Request

Amend the ‘Structure Plan’ land use policy in the *Green Hills-Midtown Community Plan: 2005 Update*

Metro Planning Commission Meeting of 11/10/05

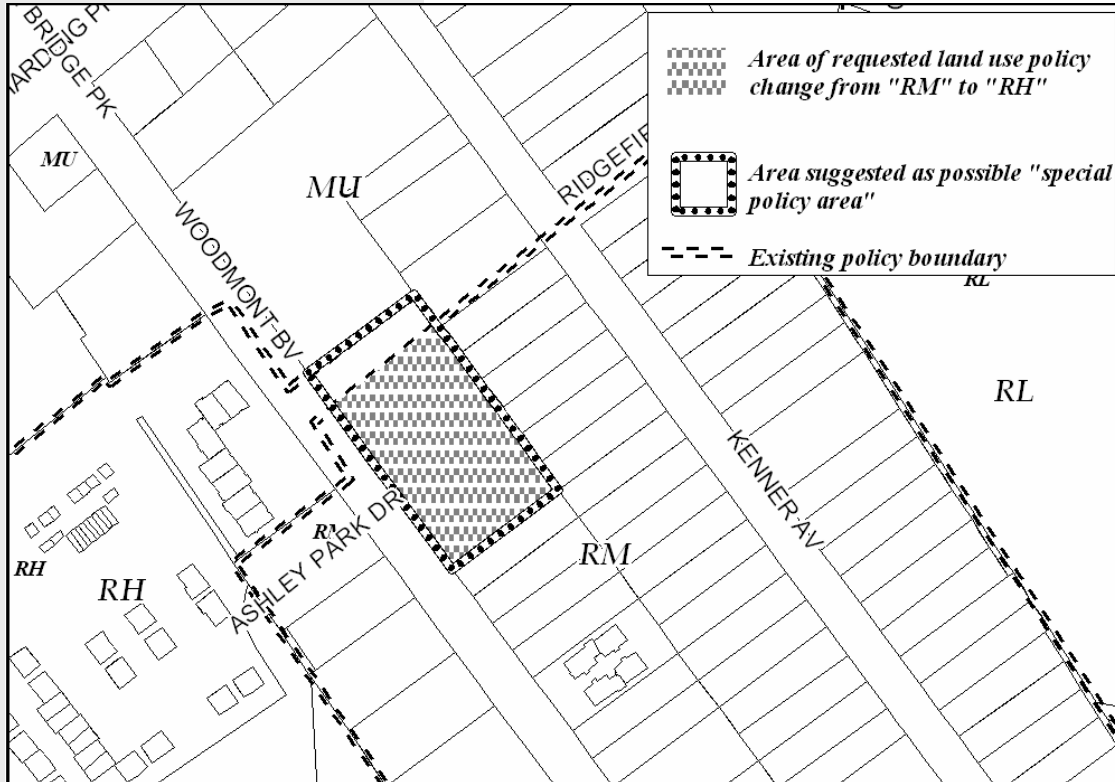
The suggested text of the special policy is as follows:

1. The intent within this area is to provide transition in the intensity of development for the North side of Woodmont Blvd. between the adjoining intense mixed-use development to the northwest and the established medium density residential area to the southeast. As part of that transition, the height of buildings should be varied, with the tallest ones, up to ten stories, in the northwestern section of the site, and the shortest ones, up to three stories, in the southeastern section of the site.

2. The southeastern edge of this area is intended to be the limit of residential development above medium densities (9 housing units/ac) along this side of Woodmont Blvd. To reinforce this boundary, generous landscaping should be provided along this edge of the site. Generous landscaping should also be provided along the edge of this area that abuts the residential development along Kenner Avenue to buffer the impact of development on those homes.

As shown in the graphic, the special policy would apply to the area for which RH policy is being requested, plus the parcel that is already in RH policy. This would be "Special Policy # 15" in the *Green Hills – Midtown Community Plan: 2005 Update*.

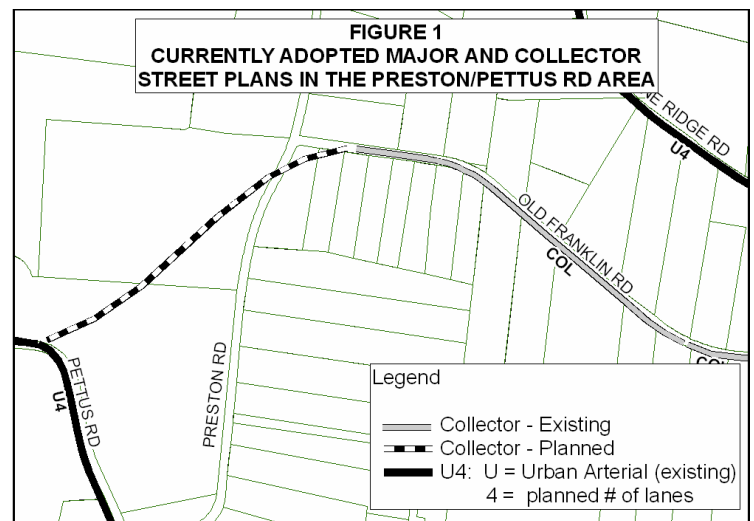
The currently adopted Major and Collector Street Plans in the vicinity of Pettus Rd, Preston Rd., and Old Franklin Rd. are shown in Figure 1.

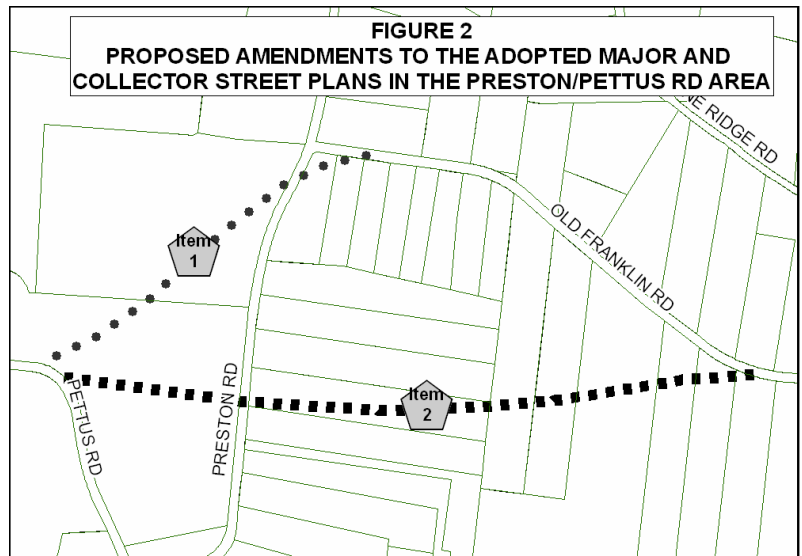
Proposed Collector Street Plan Amendment: the “Collector Street Plan” is proposed to be amended by deleting from it the segment of planned (unbuilt) collector street that extends from Pettus Rd northeastward to Old Franklin Rd in the vicinity of its intersection with Preston Rd., shown as the dotted line identified as Item 1 on Figure 2

Proposed Major Street Plan Amendment: the “Major Street Plan” is proposed to be amended by adding to it as a “U2” (Urban 2-lane arterial) a street extending from Pettus Rd. eastward to Old Franklin Pk., shown as the dashed line identified as Item 2 on Figure 2.

The adopted Major and Collector Street Plans are the official guides for determining how these types of streets are taken into account and reflected in the layout of proposed developments. As can be seen by comparing Figures 1 and 2, there is an inconsistency between the currently adopted major and collector street plans and the plans for those streets as recommended in the community plan.
